City of Portland, Maine - Building or Use Permit Application

Permit No: 09-0510	Issue Date:	CBL: 003 K003001
-----------------------	-------------	---------------------

Location of Construction: 22 VESPER ST	Owner Name: VESPA LLC	Owner Address: 20 COVESIDE RD	Phone:
Business Name:	Contractor Name: Rob Krouskup	Contractor Address: 8 Clover Leaf Lane Scarborough	Phone 2072403668
Lessee/Buyer's Name	Phone:	Permit Type: Alterations - Multi Family	Zone: R-6

Past Use: 3 Unit Residential	Proposed Use: 3 Unit Residential - install foundation (12'6" x 11'6 7/16") under existing 1st story - enclose 2nd & 3rd floor decks over existing 1st floor - reconfigure 1st floor deck & add 2nd & 3rd floor decks w/in	Permit Fee: \$400.00	Cost of Work: \$38,000.00	CEO District: 1
Proposed Project Description: install foundation (12'6" x 11'6 7/16") under existing 1st story - enclose 2nd & 3rd floor decks over existing 1st floor - reconfigure 1st floor deck & add 2nd & 3rd floor decks w/in existing footprint - add rear entry		FIRE DEPT: <i>w/ conditions</i> <input checked="" type="checkbox"/> Approved <input type="checkbox"/> Denied 6/4/09	INSPECTION: Use Group: R-2 Type: SB DBL-2003 Signature: <i>[Sign

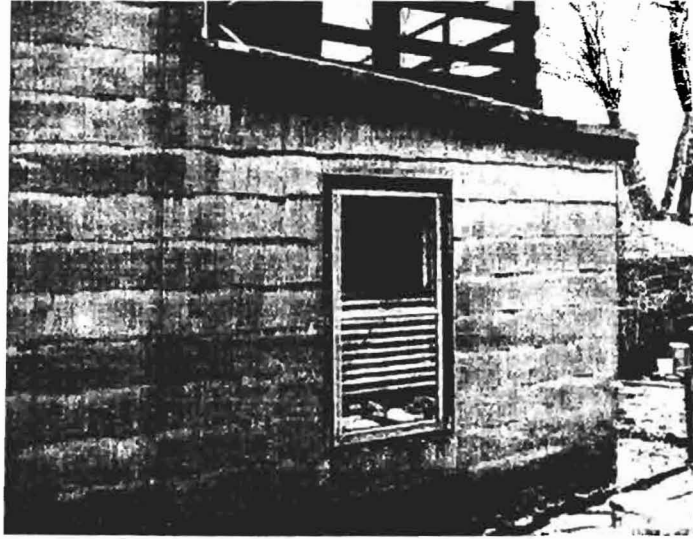
Using section 14-436(b) to add second story over existing 1st story in rear.

80% of 1593 = 1274.4

adding: 10'10" x 11'6" =

10.83 x 11.5 = 124.55 sqft

using 10% of allowable increase.

side setback - 10' existing - right 1' proposed - same - right
" left 10.75' " left 14.67'

rear setback - 20' existing 9' (from rear stairs) proposed same.

lot coverage 50% = 1600

new rear entry adds 18.06 sqft but removed 36 sqft side porch

OK

Using section 14-427 to enclose the 3rd floor porch - majority of walls are glass.

Using section 14-382(d) to expand the third floor porch 1'5" to edge of building to match 2nd's 3rd floor - "... addition may be made ... proposed change in existing exterior wall and/or roof would be within space occupied by existing shell of building.

Using section 14-425 to add one story entry porch extends 4.35' off building; 18.06 sqft footprint.

22 VESPER
CEILING CROSS SECTION

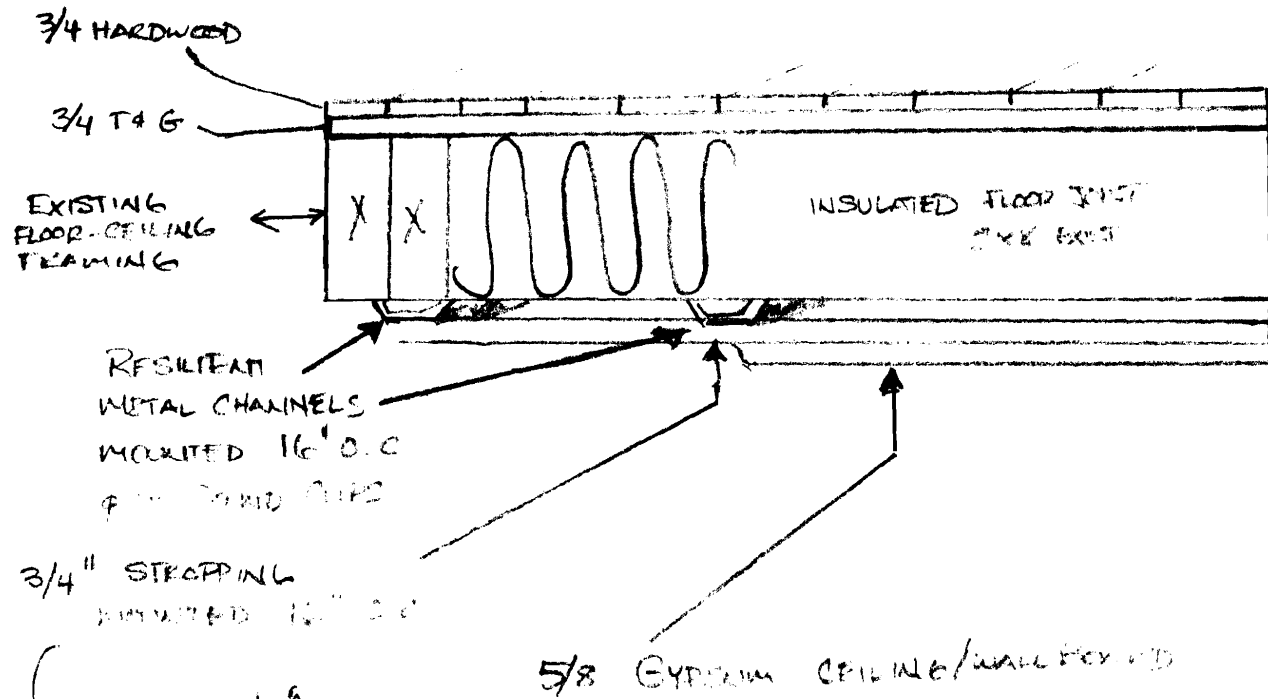
Bob has

detail spec
from channel

man. to apply
strapping over channel

Asked for a copy of this

11'-3" 6'11"
PROPOSED ~~11'-1" X 11'-7"~~
DECK FRAMING PLAN - see revised plans
6/17/09 for size of decks.

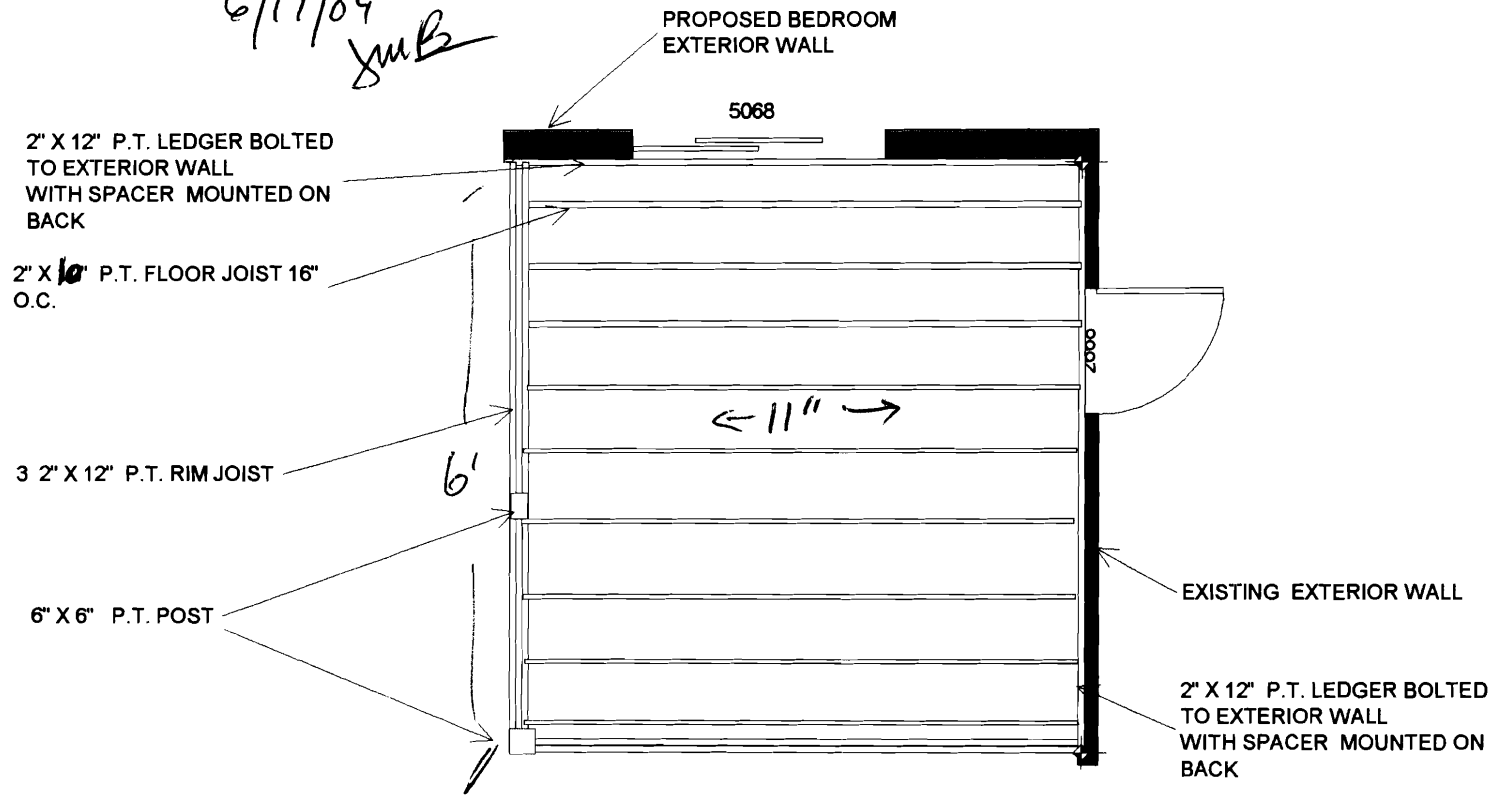
6/17/09
JMB

Exterior Stairs Back Deck and Entry

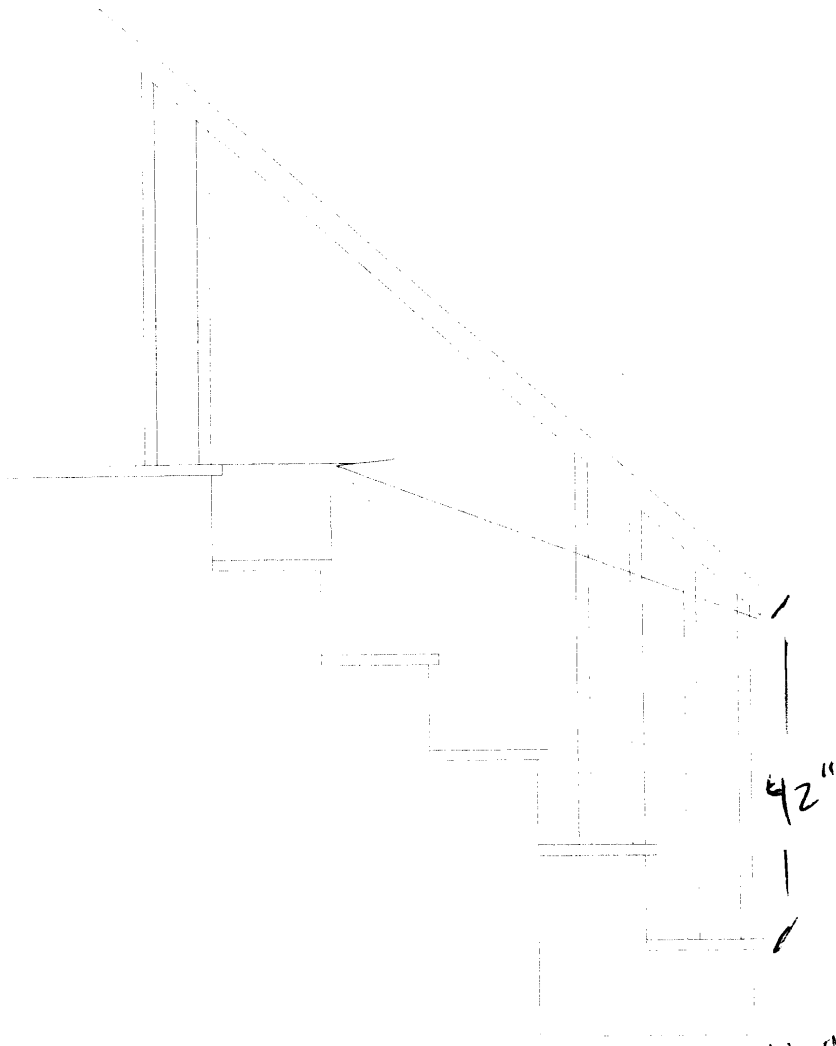
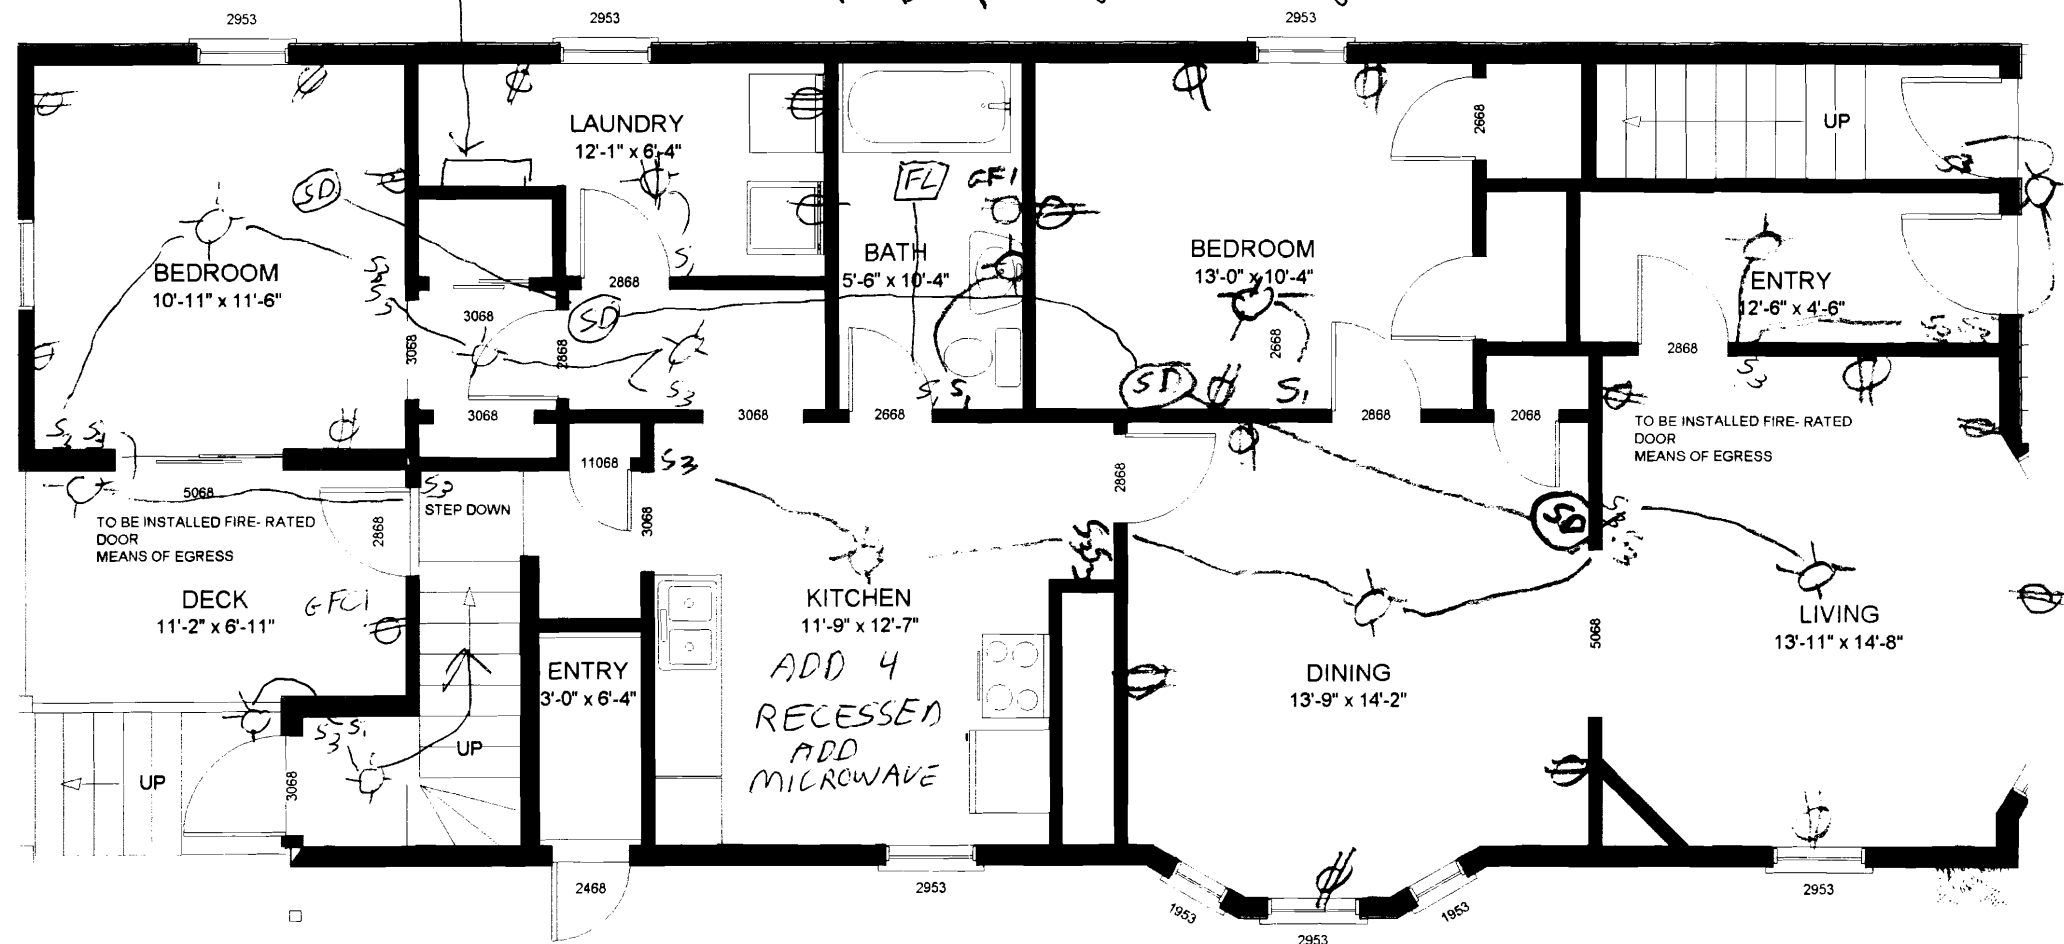
~~1" overhang nosing on stair treads~~
90° w/ minimal overhang

*w/ handrail
@ 34"-38"
Returned
per Bob K.
6/17/09*

PROPOSED REAR ELEVATION
SCALE 1/8" = 1'-0"

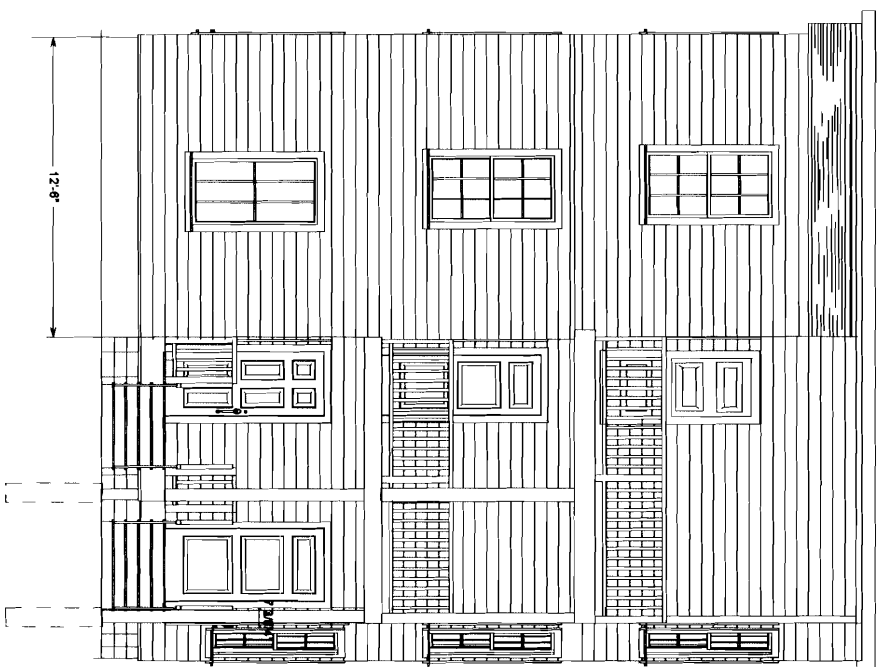
Old - screen side

**PROPOSED
THIRD FLOOR
PLAN**

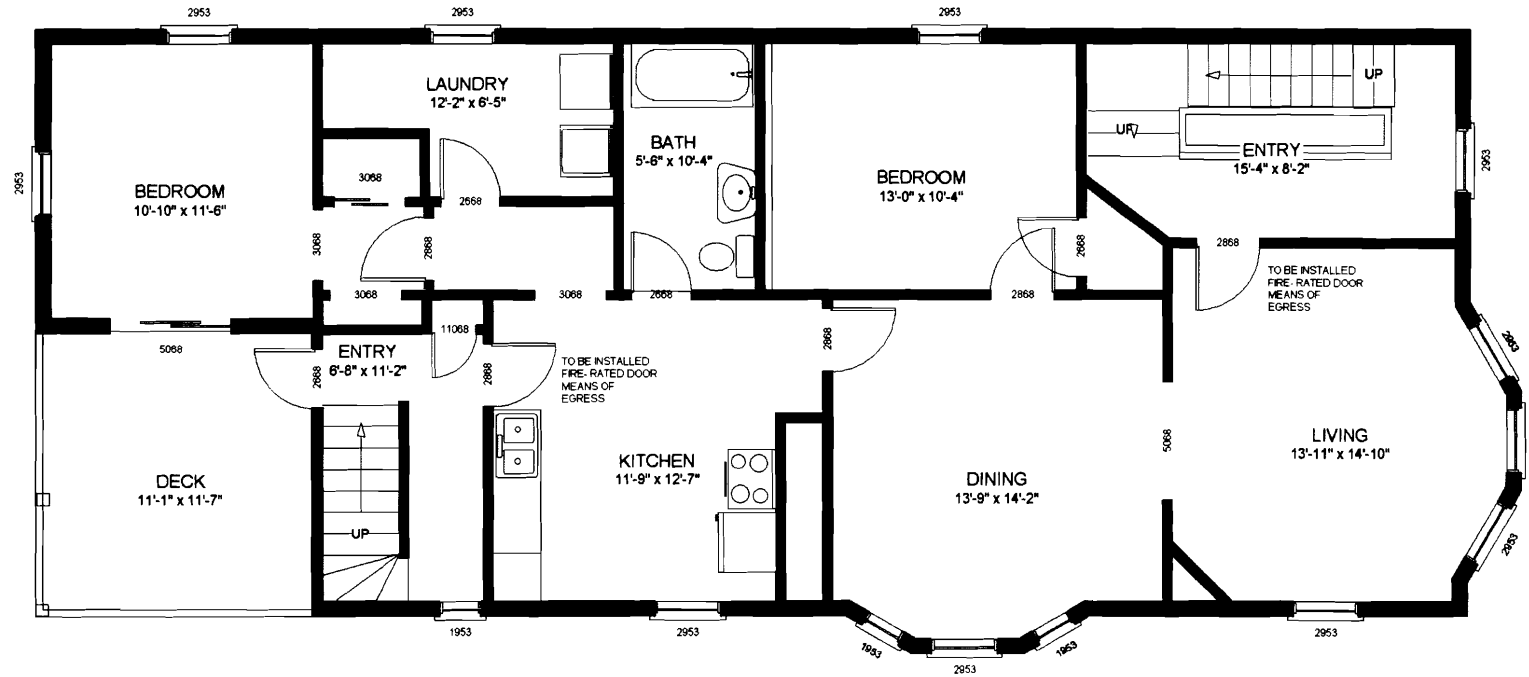
Old - see revised 6/1/09

PROPOSED
FOUNDATION FLOOR
PLAN
SCALE 1/8" = 1 FOOT

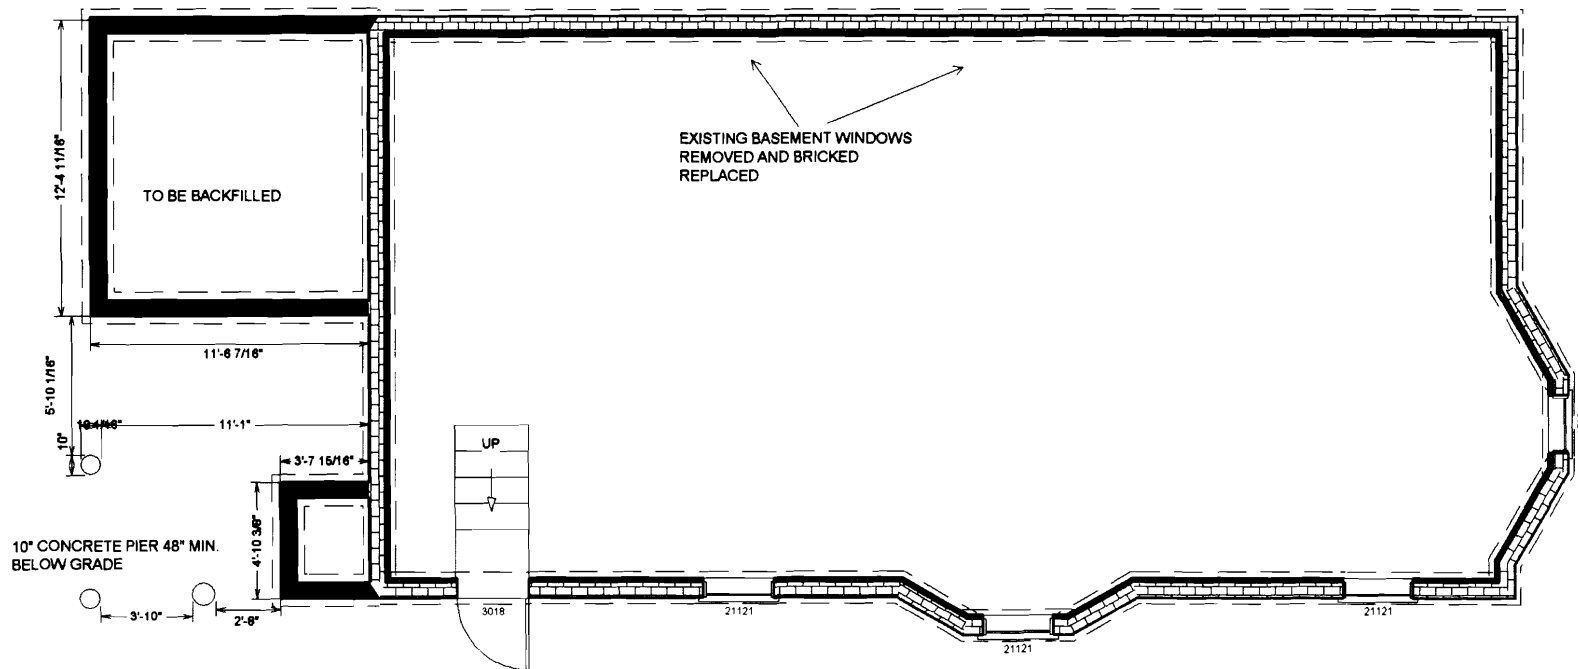
*Old-new plan submitted
6/1/09*

**PROPOSED
SECOND
FLOOR PLAN**
SCALE 1/8" = 1 FOOT

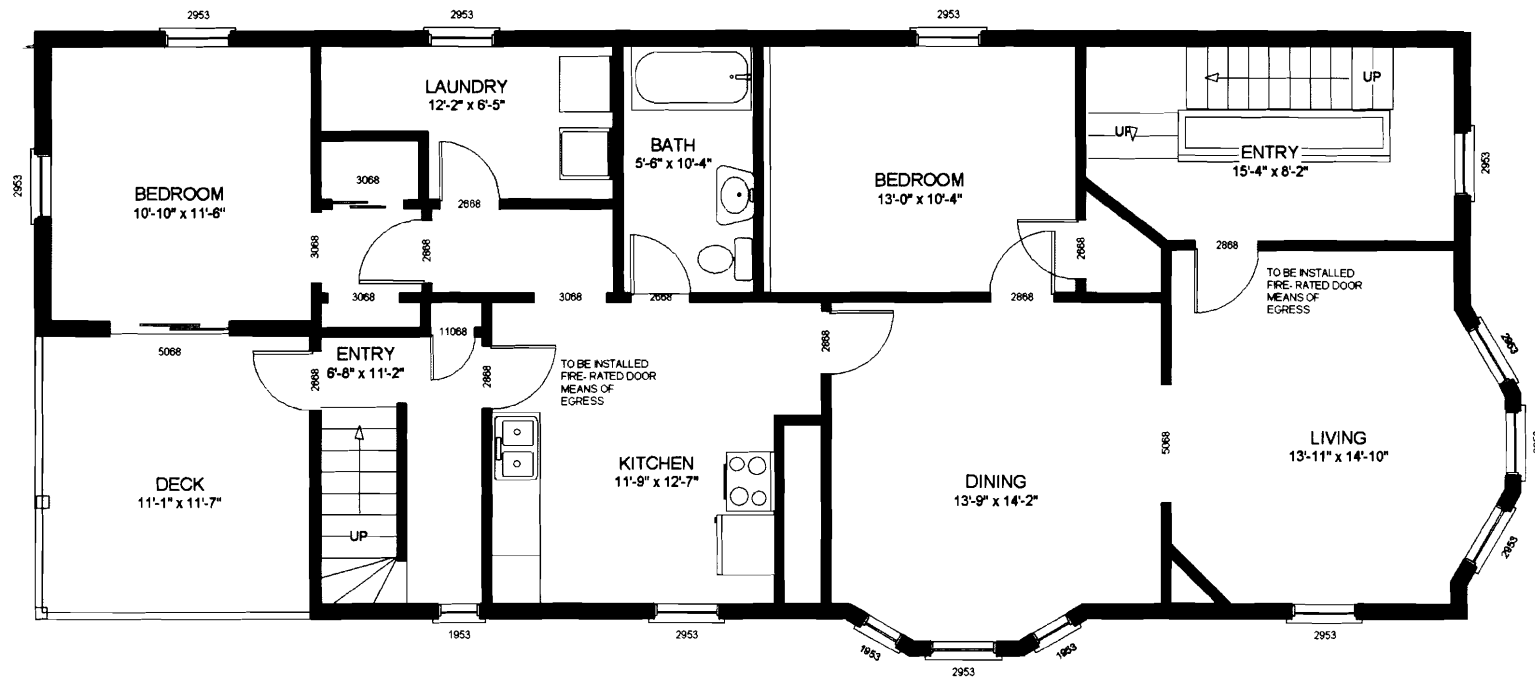
*Revised
see 6/1/24 plan*

**PROPOSED FIRST FLOOR
PLAN**
SCALE 1/8" = 1 FOOT

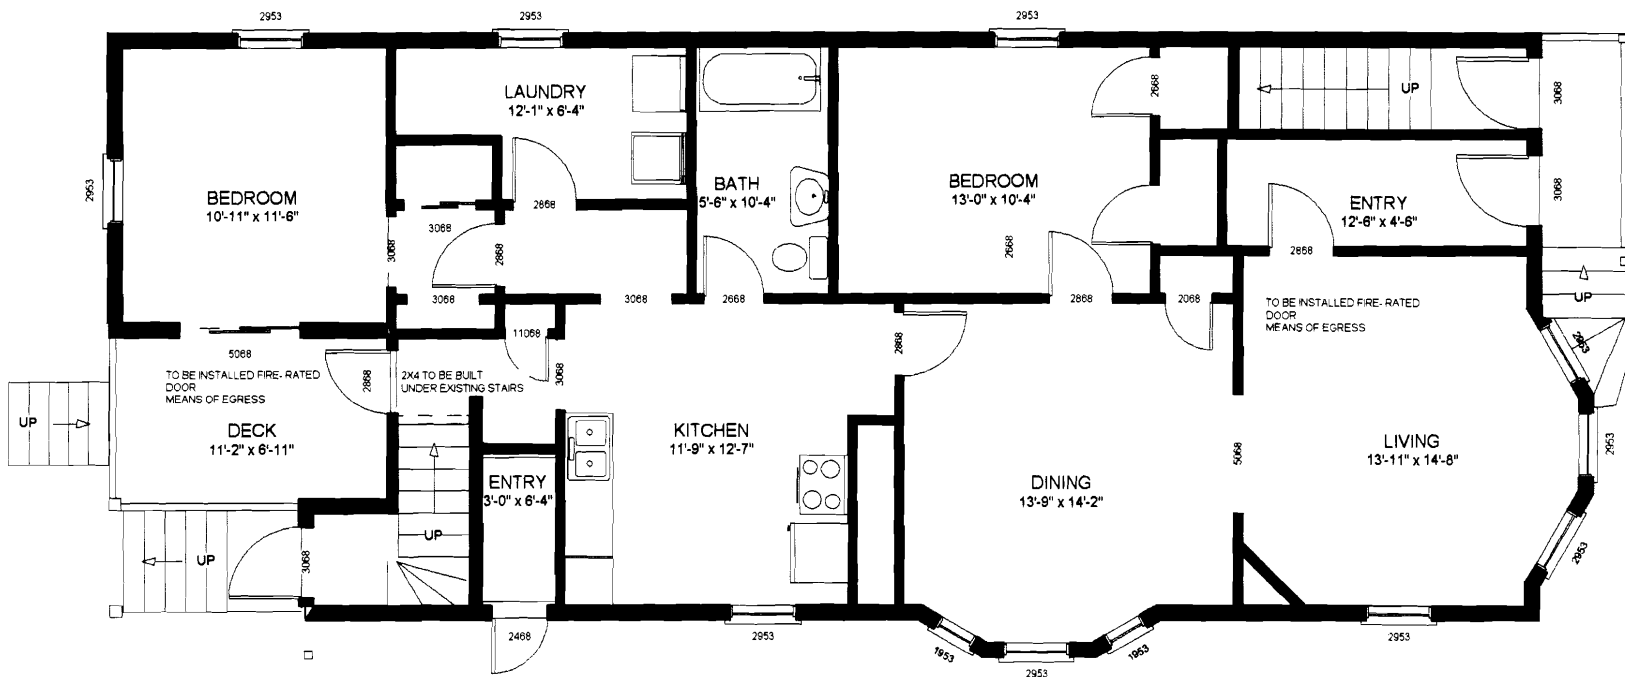
*old-revision submitted
6/1/09*

↑ is this b
b isomet?
